Addendum No. 2 for: LASSEN COUNTY SUSANVILLE VETERAN'S MEMORIAL BUILDING

ROOF REPLACEMENT PROJECT.

APPENDIX B

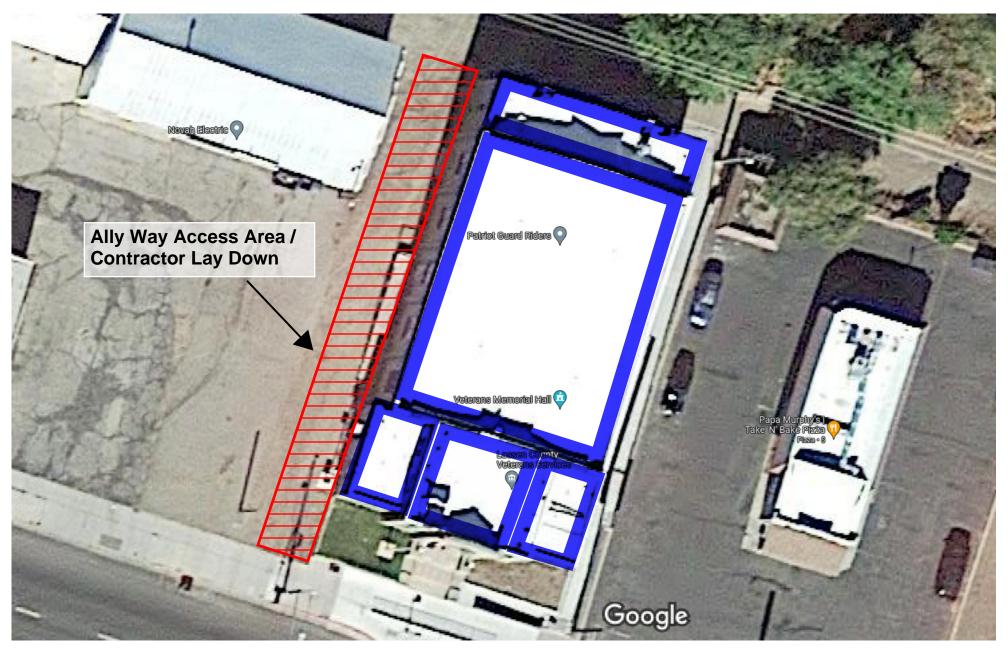
"The Project consists of removal of existing roofing system to existing sheathing / sub straight at all parapet walls and transition walls, as well as a 3' strip from the inside corner of the walls along the perimeters of the roof. See attached sketch titled Appendix B, illustrating the extent of removals. Install Versico's VersiWeld (TPO) Roofing System, or approved equal, over entire roof as outlined below:"

: Extent of existing roof membrane system removals (parapet walls and 3' from parapet wall typ.)
